Shearon Harris Nuclear Power Plant, Unit 1  
Docket No. 50-400/Renewed License No. NPF-63

Subject: Response to Request for Additional Information #3 Regarding License Amendment  
Request to Revise Technical Specification Table 3.3-4 Loss of Offsite Power 6.9 kV  
Emergency Undervoltage Primary Setpoints (TAC No. MF4294)

Response to Request for Additional Information #3  
License Amendment Request to Revise Technical Specification Table 3.3-4  
Loss of Offsite Power 6.9 kV Emergency Undervoltage Primary Setpoints

**ELECTRICAL RELAY LOGIC DIA.  
DIESEL GENERATOR CONTROLS  
UNIT 1**

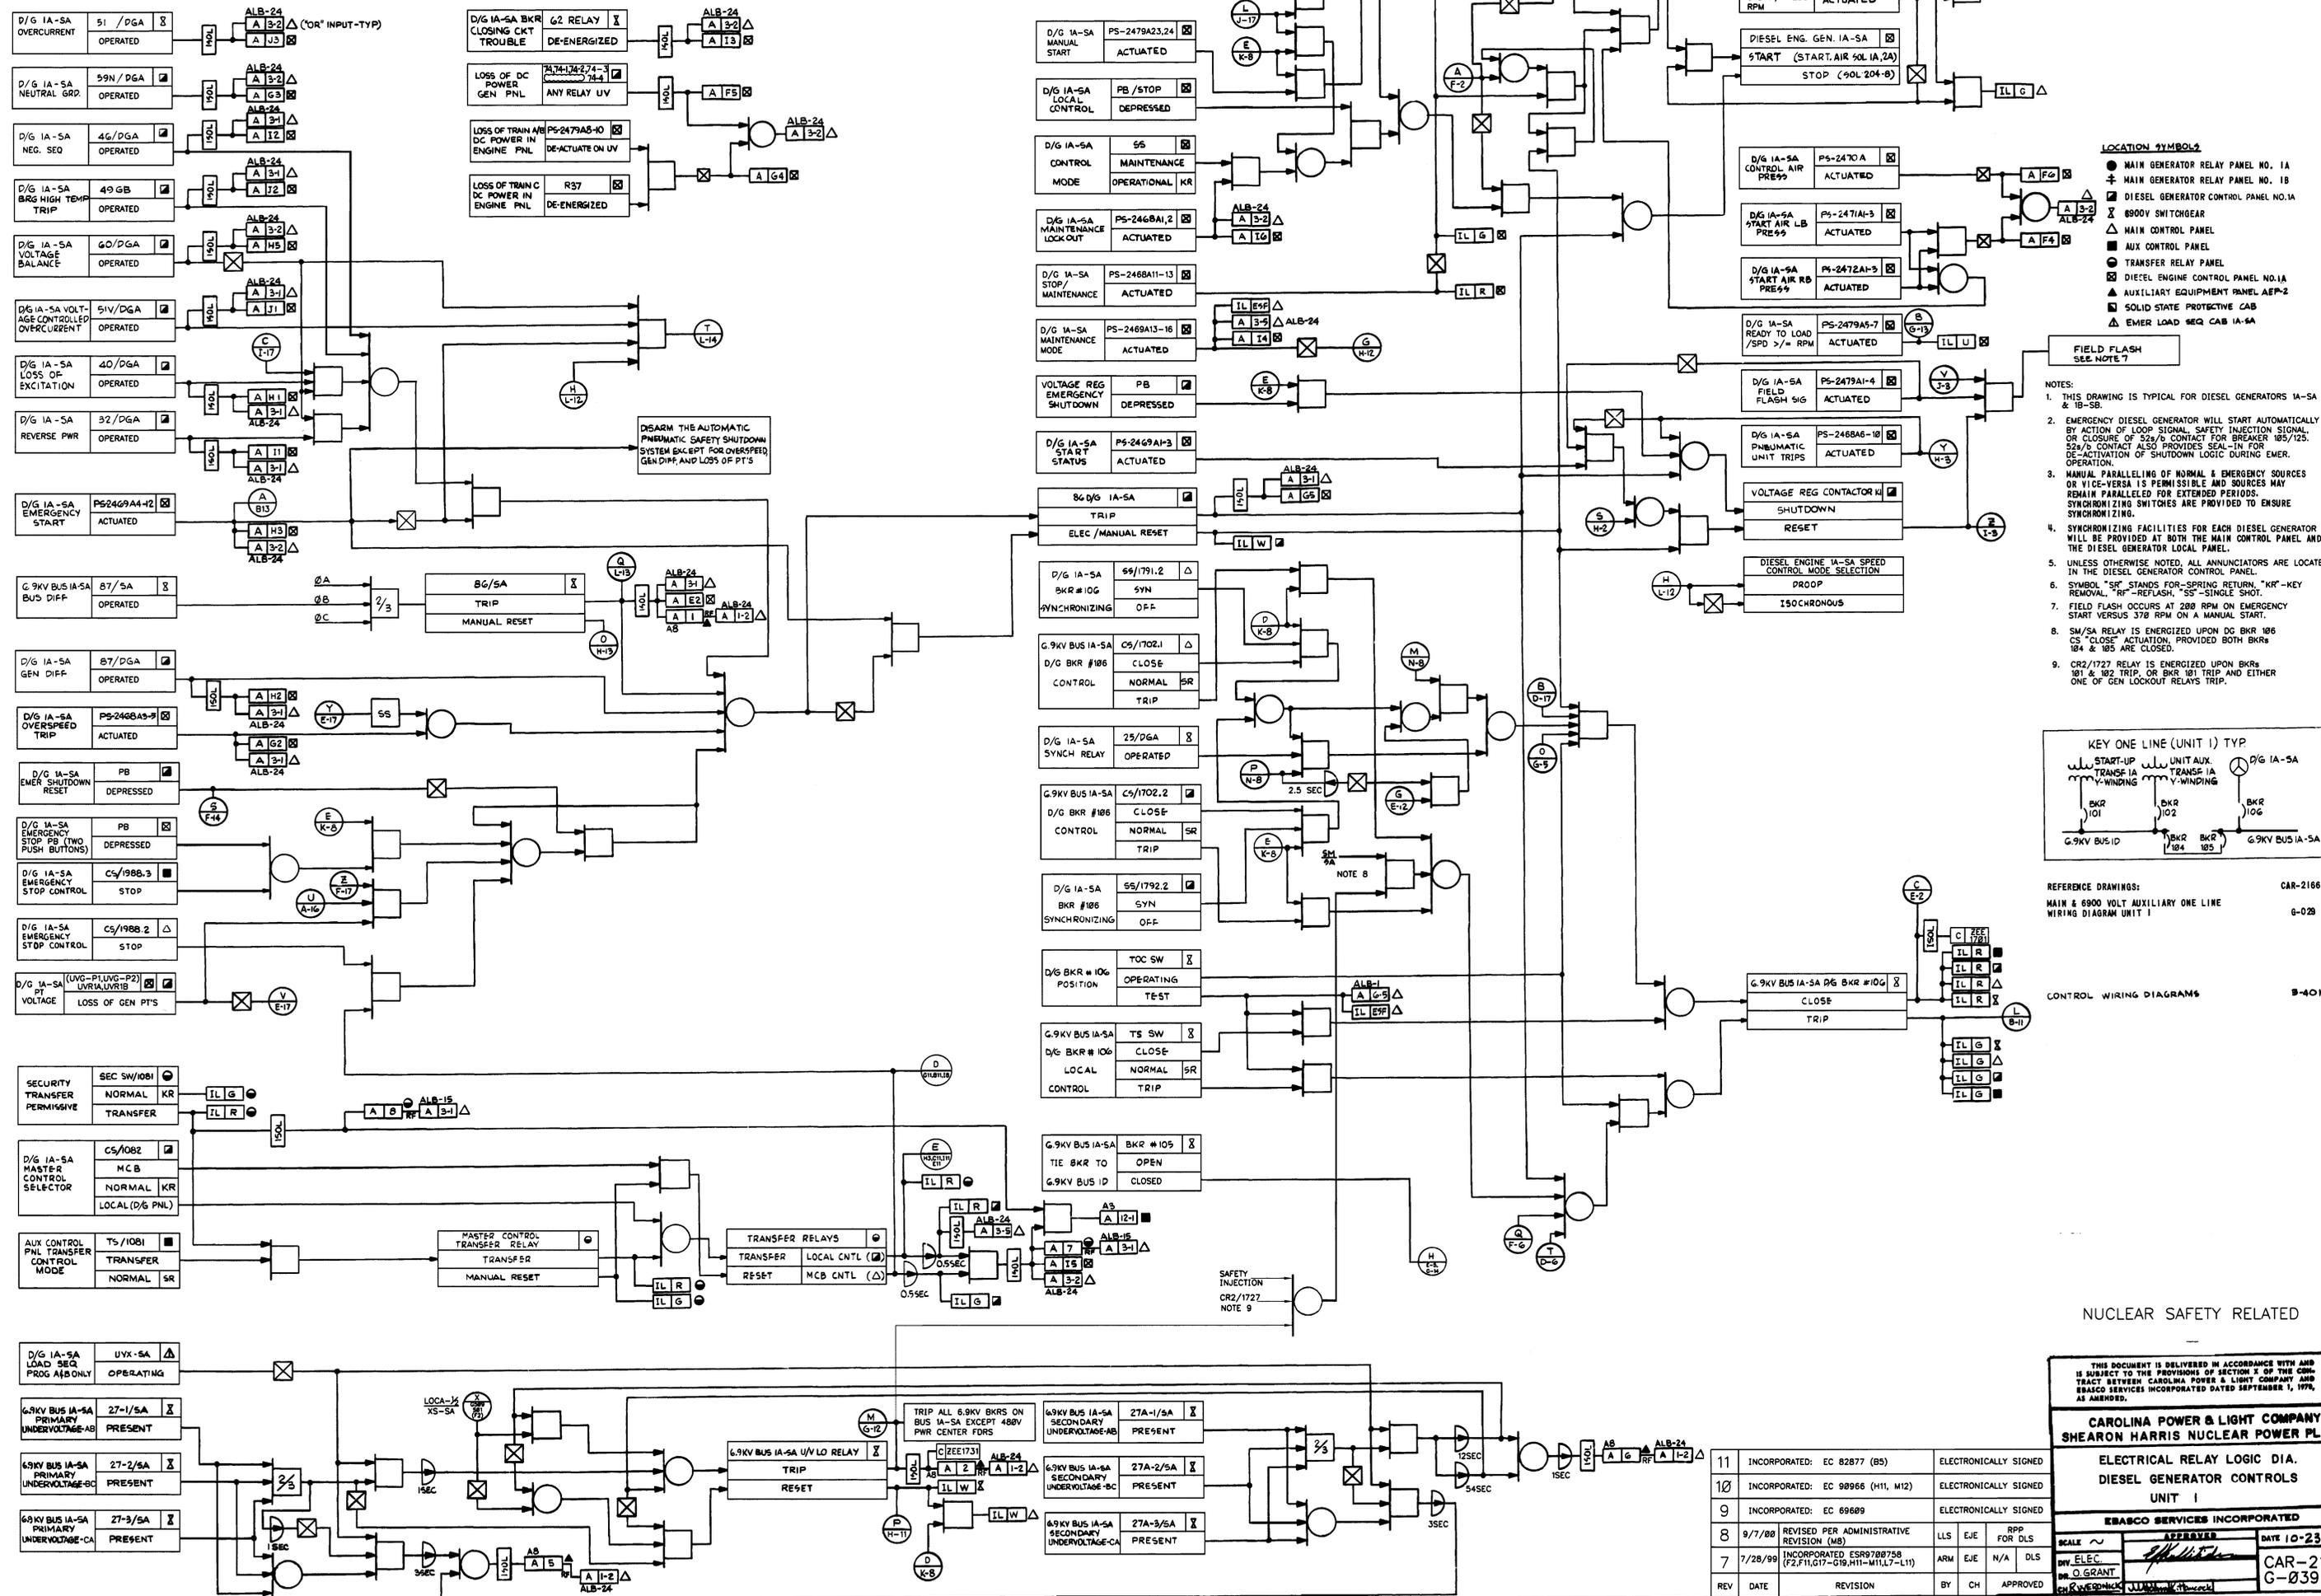
Please clarify whether the LOV protection logic is unblocked after the EDG loading is completed. Provide a copy of the logic diagram of LOV and Degraded Voltage protection when a 6.9 kV emergency bus is fed from an offsite source and when fed from an EDG.

Both the primary (LOV) and secondary (degraded voltage) undervoltage protection schemes are "blocked" after re-energization of the emergency power system by the Emergency Diesel Generators following either a LOOP event or a LOOP with loss-of-coolant accident (LOCA) event. The LOV logic is blocked both during and after sequencing. The blocking circuit (provided by Sequencer Cabinet Relay UVX) is "sealed-in" until the operators restore offsite power to the emergency power system by re-closing the tie breakers to the balance-of-plant system, opening the EDG breaker, and resetting safety injection (if applicable).

Diesel Generator Logic Diagram 6-G-0039 (bottom of drawing) shows the logic for both the primary (LOV) and the secondary (degraded voltage) undervoltage protection

schemes. The logic diagram shows that the trip function is only active if the Emergency Load Sequencer is not running either Program A (LOOP) or Program B (LOOP with loss-of-coolant accident).

Attached is 6-G-0039, Electrical Relay Logic Diagram – Diesel Generator Controls.
